Planning Commission Meeting Agenda

Thursday, March 11, 2021
7:00 PM

Hartland Township Planning Commission Meeting Agenda Memorandum

Subject: Site Plan Application #20-011 Villas of Hartland Planned Development (PD) – Preliminary Site Plan

OS

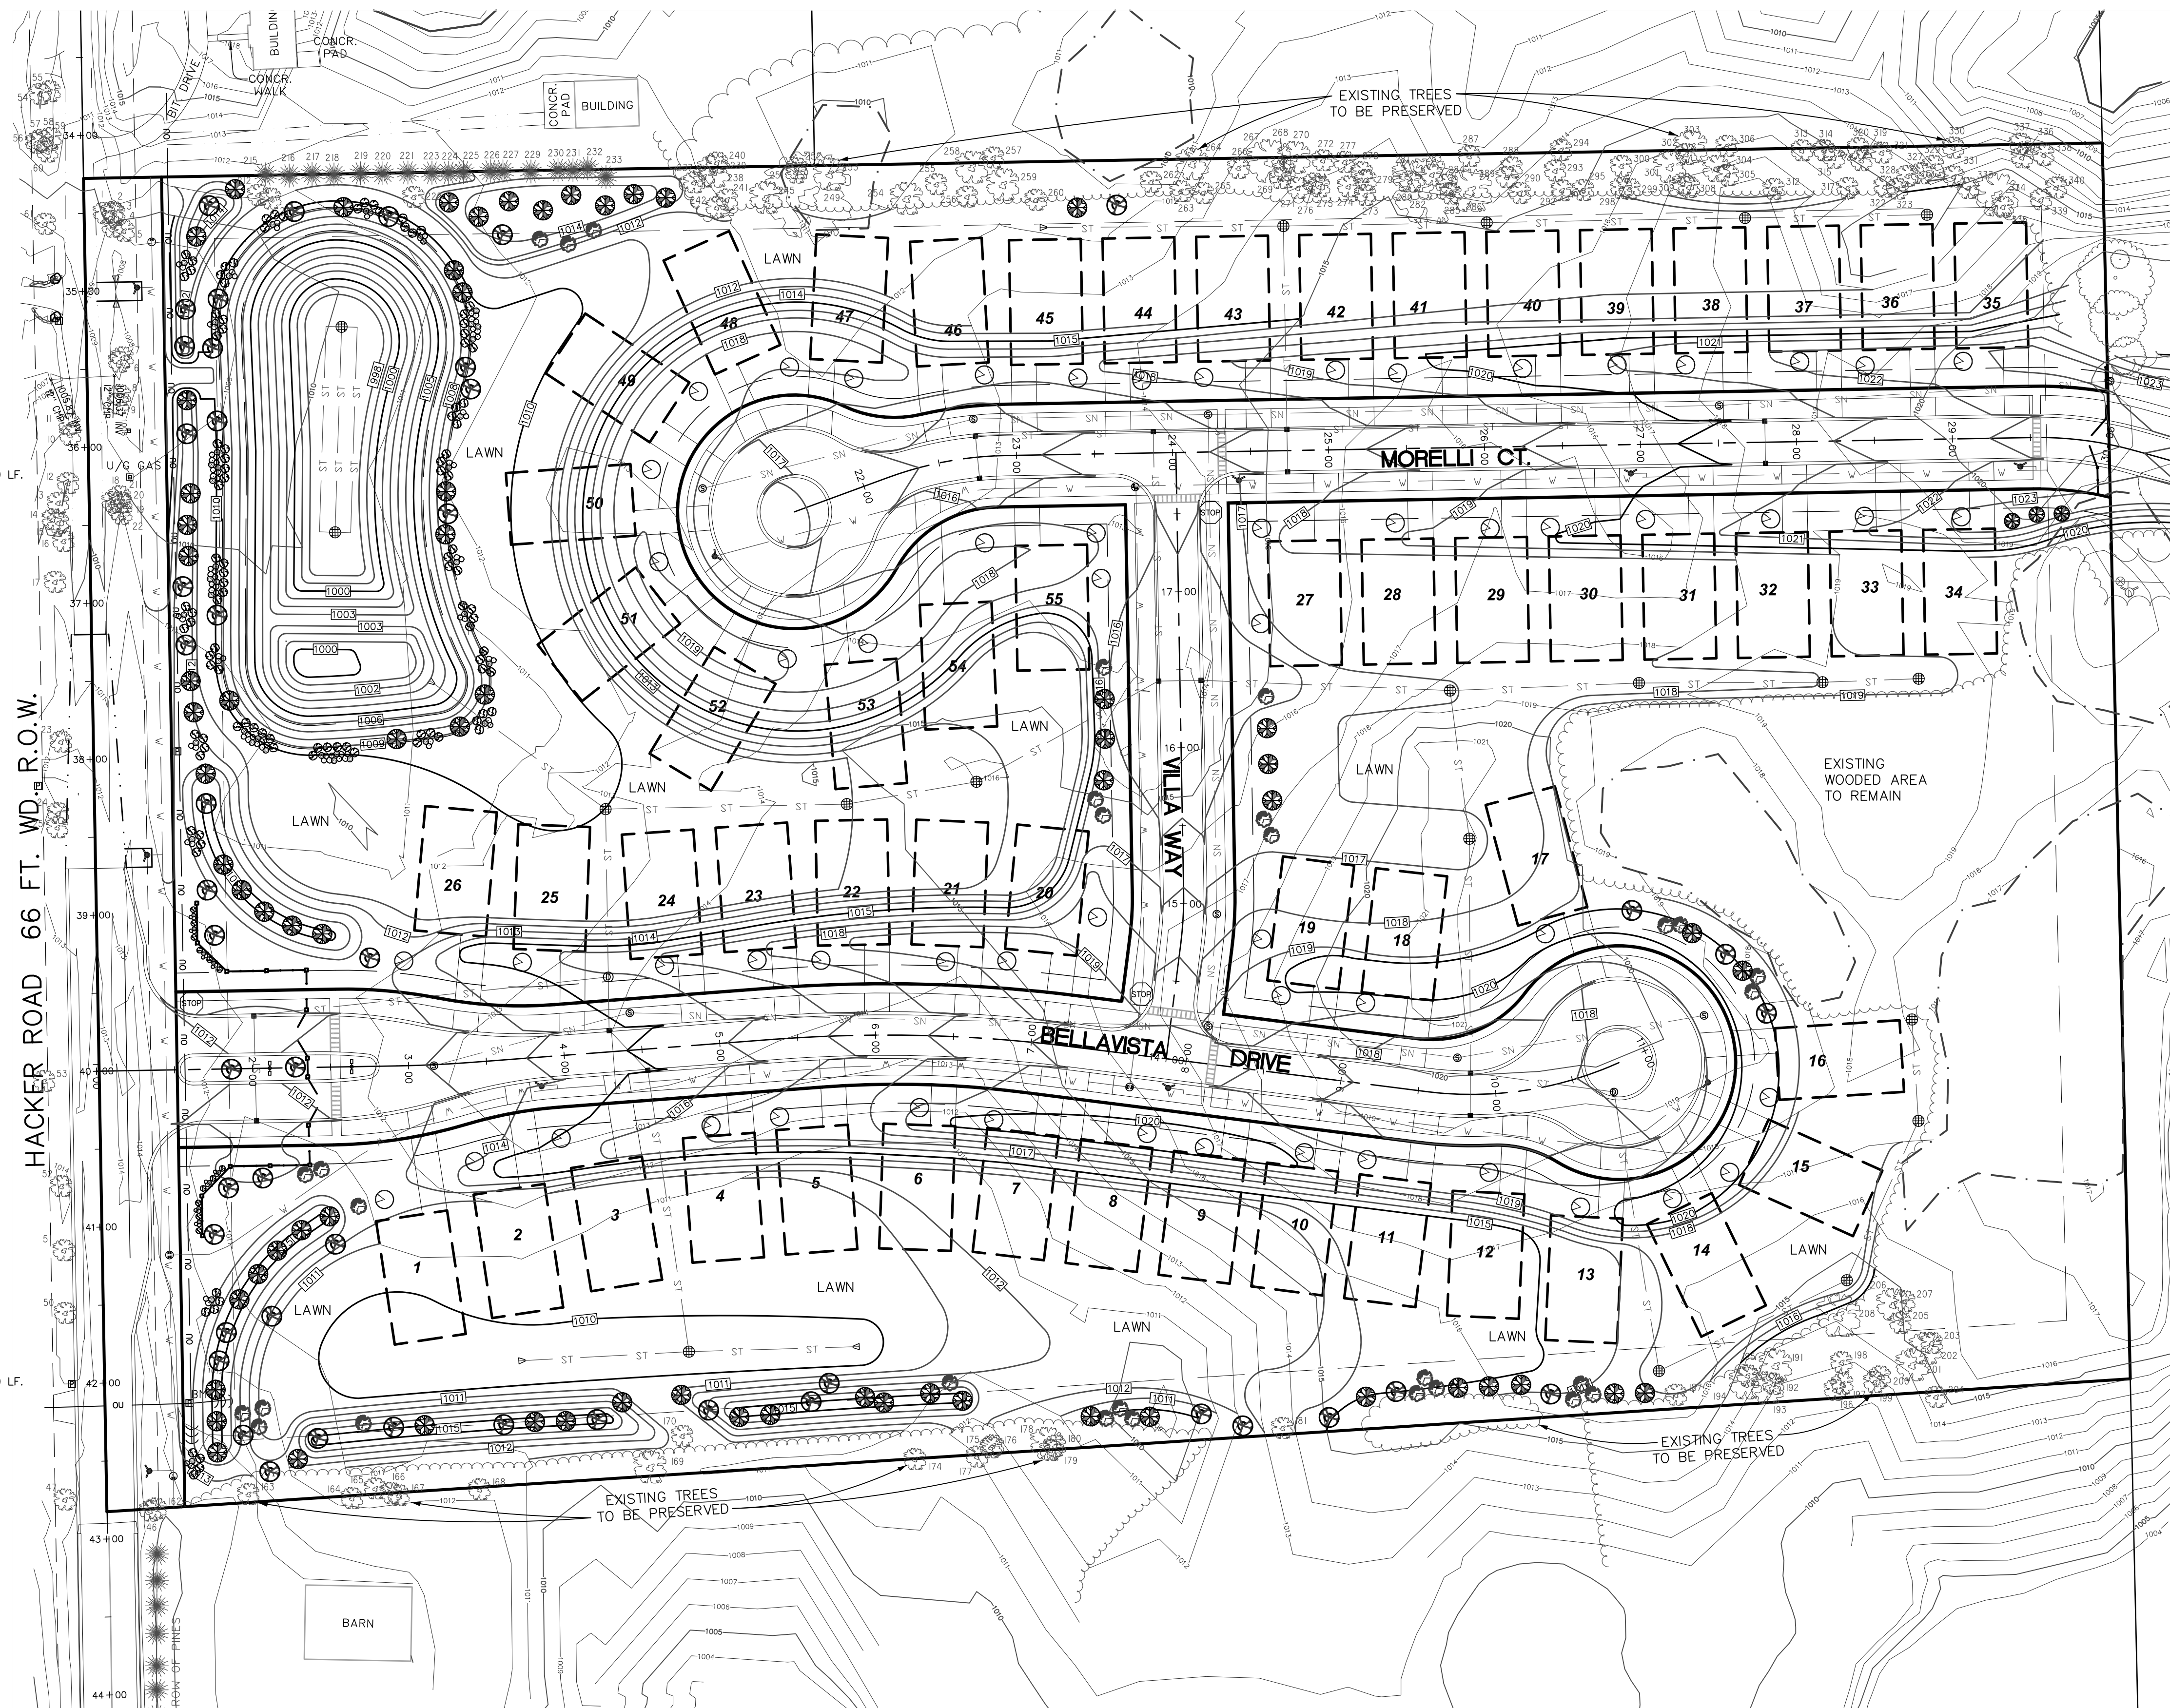
The Preliminary Plan states the proposed open space is 42% of the site, or approximately 10.28 acres; and 3.76 acres as useable open space, or 15.3% of the site. The Open Space Plan shows useable open space (cross-hatched areas) along a portion of the frontage of Hacker Road, along the south side of the site, on the west side of the units on the cul-de-sac of Morelli Court, and two (2) areas in the center of the development. Details on what amenities are provided in the useable open space areas are not noted.

CONCEPTUAL DECORATIVE GATE DETAIL
NOT TO SCALE

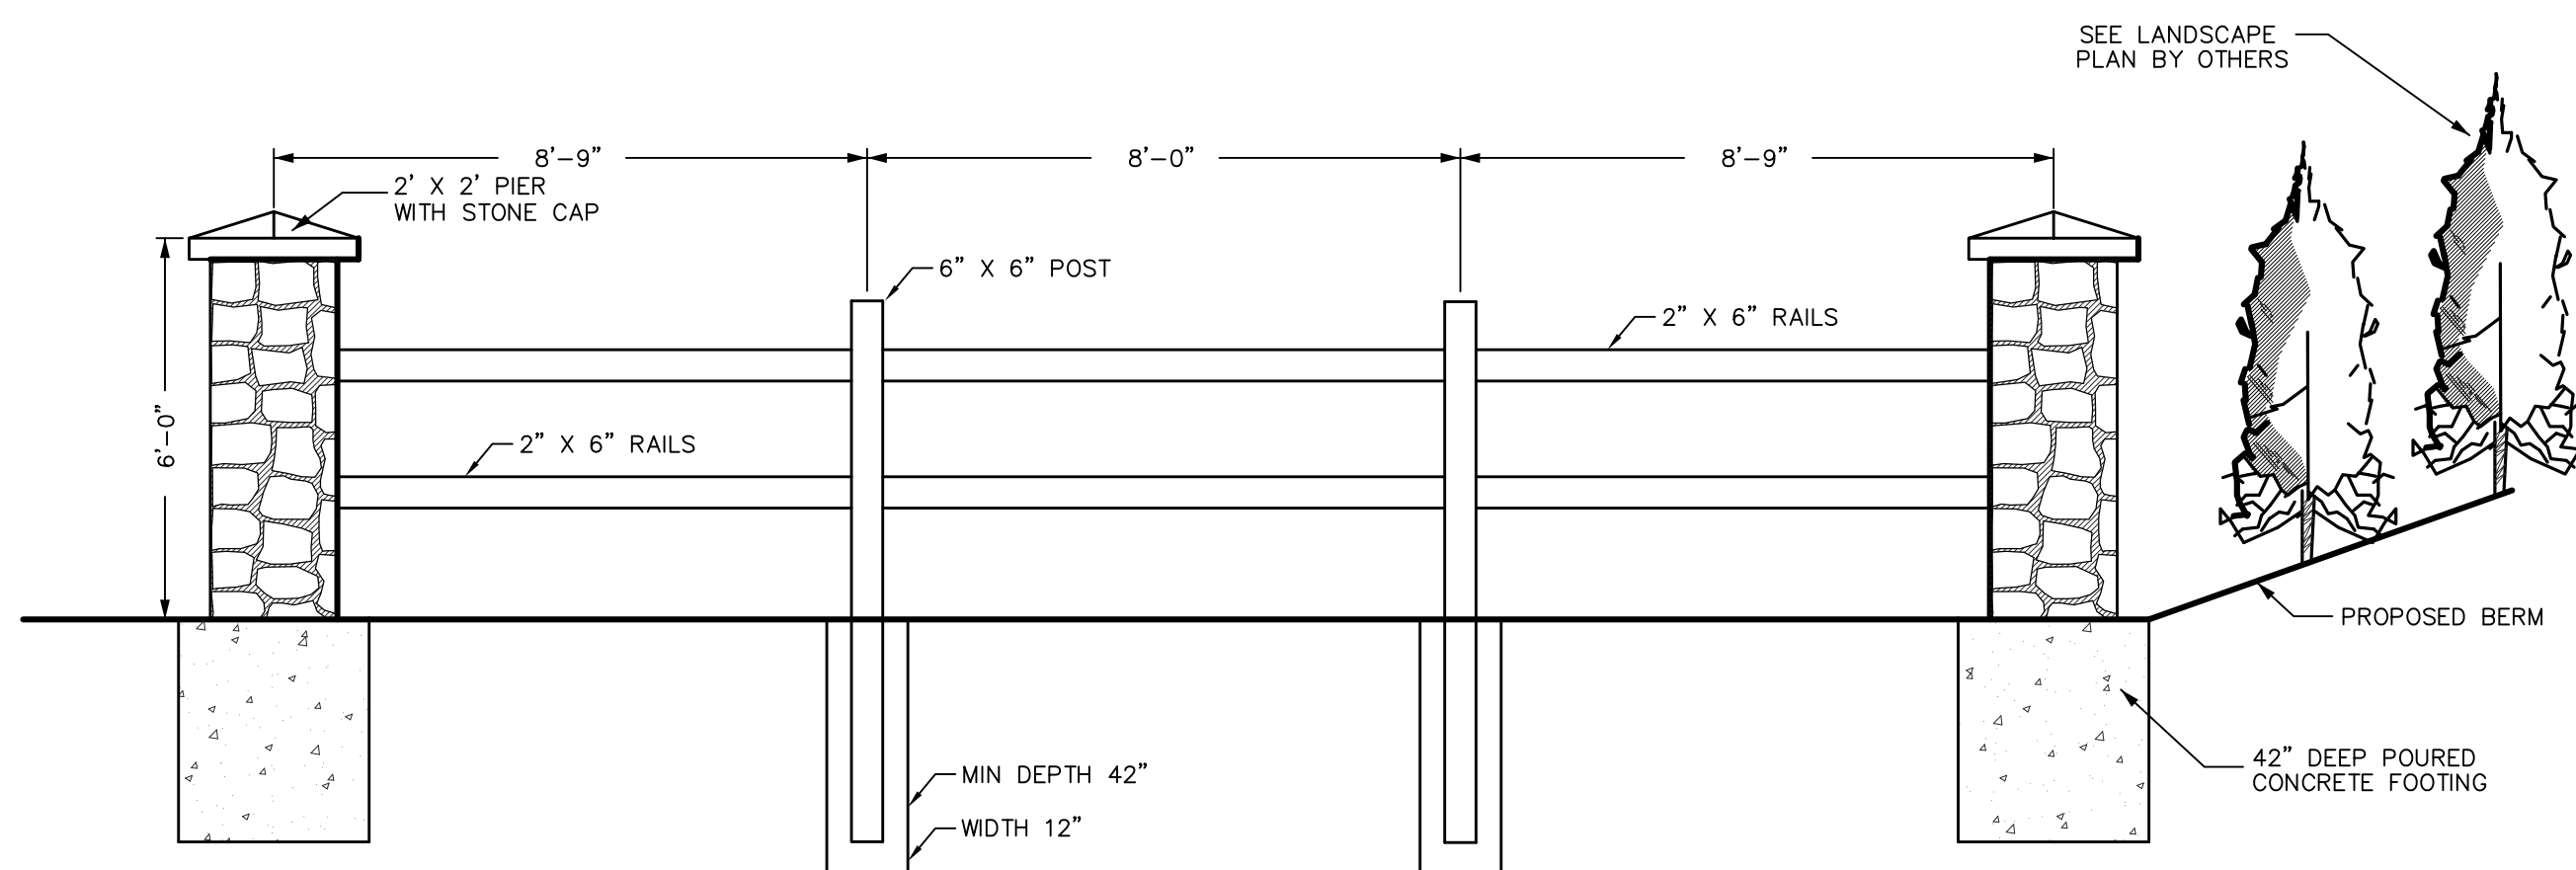
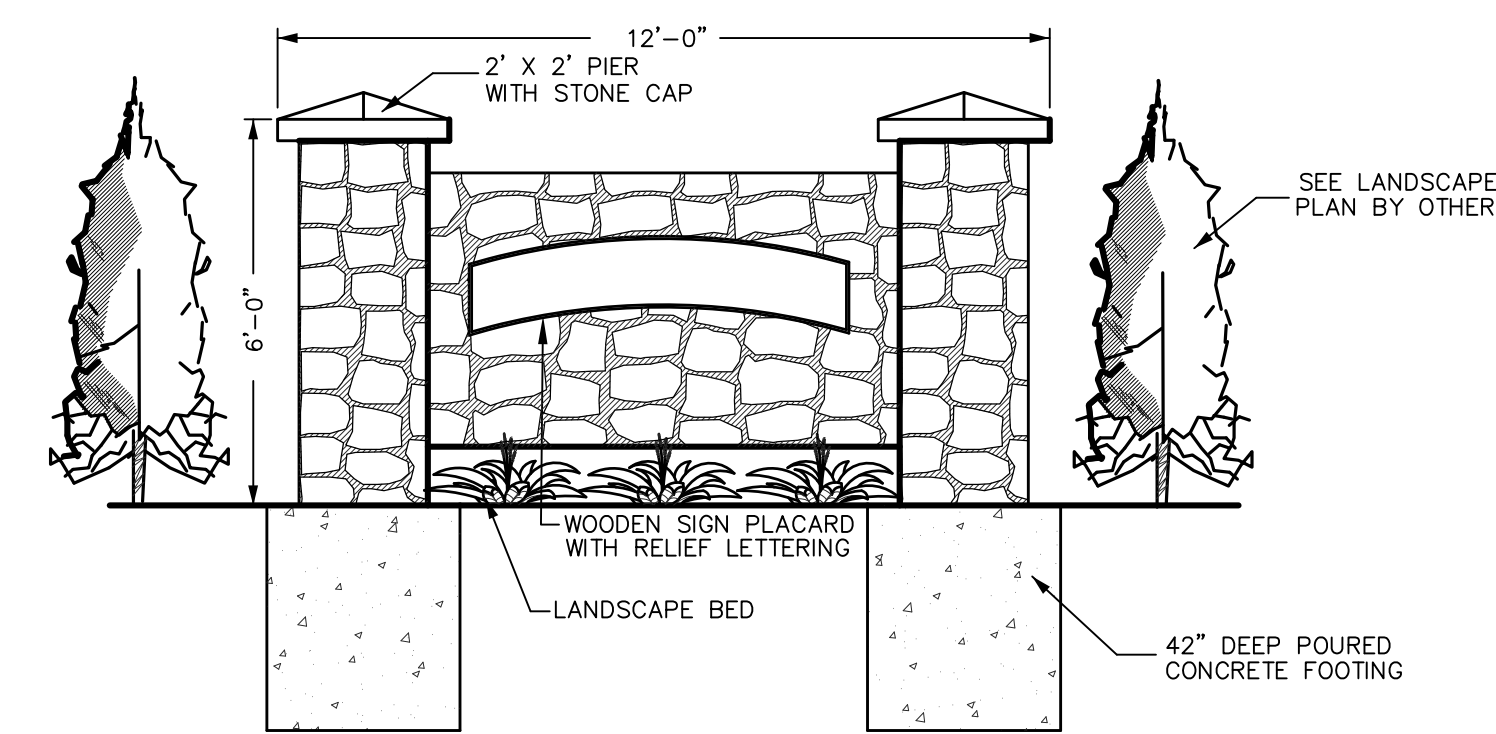
Per the applicant's letter, the gates add prestige to the subdivision and provide a sense of security for its residents. The applicant explains that the presence of the gates will slow down traffic through the development. The gates are equipped with an electronic eye which automate the opening and closing of the gates. The opening of the gates will be likely controlled by IR motion sensor or proximity loop in the pavement, the applicant's explanation. Staff assumes the gates will operate 24 hours a day and will automatically open for any approaching vehicle. Clarification should be provided by the applicant and potentially be detailed in the Master Deed.

The proposed gated, emergency access may be in conflict with this standard as well as the stated goals of the Comprehensive Plan which calls for connectivity between neighborhoods. Commonly accepted planning principals promote vehicular and pedestrian connectivity between neighborhoods to provide health, safety and welfare benefits for the community.

7. As part of the Final Plan Review, the applicant shall provide a Master Deed and Planned Development (PD) Agreement that indicates any gates on the roadway that connects to Walnut Ridge Subdivision shall have an automatic style sensor that opens for all traffic at all times. In the event of a power failure, these gates shall have the ability to be manually opened. All gates shall meet the approval of the Hartland-Deerfield Fire Authority
